Access Compliance Report

Public Rights-of-Way

(Curb Ramps)

Intersection ID: 5408	Main Street: CARVER_PL	Cross Street: ROCKWELL_BV	Location: W
ADA ID: 424E6814F4B8	Ramp Type: Para	Initial Pass/Fail: Fail	Overall Compliance: No
Severity Score: 43.75			
Codes/Mitigation Info/Possible Solution		Field Measurements/Component Compliance

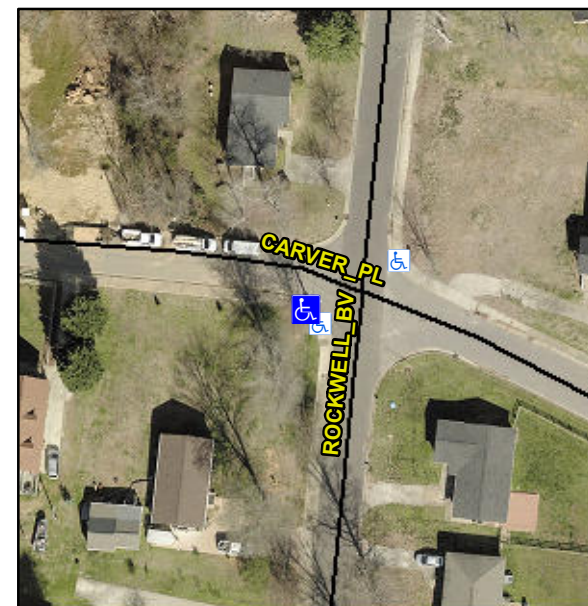
POWER POLE OBS

R304.5.1, R304.3.2, R304.5.3

Compliance	Description	Data	Compliance	Description	Data
N/A	Ramp Length LT (in)	32.0	N/A	Ramp Length RT (in)	56.0
No	Ramp Width LT (in)	41.0	No	Ramp Width RT (in)	35.0
No	Ramp Slope LT (%)	14.3	Yes	Ramp Slope RT (%)	6.5
Yes	Ramp XSlope LT (%)	1.2	No	Ramp XSlope RT (%)	2.6
N/A	Landing Length (in)	N/A	N/A	DWS Provided?	N/A
N/A	Landing Width (in)	N/A	N/A	DWS Contrast?	N/A
N/A	Landing Slope (%)	N/A	N/A	DWS Length (in)	N/A
N/A	Landing X Slope (%)	N/A	N/A	DWS Full Width?	N/A
N/A	Landing Curb? (Y/N)	N/A	N/A	DWS Offset (in)	N/A
N/A	Shared Landing?	N/A			
N/A	Gutter Ponding?	N/A	N/A	Gutter Slope (%)	N/A
N/A	Gutter Lip Ht (in)	N/A	N/A	Gutter X Slope (%)	N/A
N/A	Painted X Walk1?	No	N/A	Painted X Walk2?	N/A
	X Walk 1 Direction	To N		X Walk 2 Direction	N/A
N/A	X Walk 1 Width (in)	N/A	N/A	X Walk 2 Width (in)	N/A
	X Walk 1 Slope (%)	3.1		X Walk 2 Slope (%)	N/A
	X Walk 1 X Slope (%)	4.1		X Walk 2 X Slope (%)	N/A
N/A	Ramp inside XWalk1?	N/A	N/A	Ramp inside XWalk2?	N/A

Remove & Replace Entire Ramp.
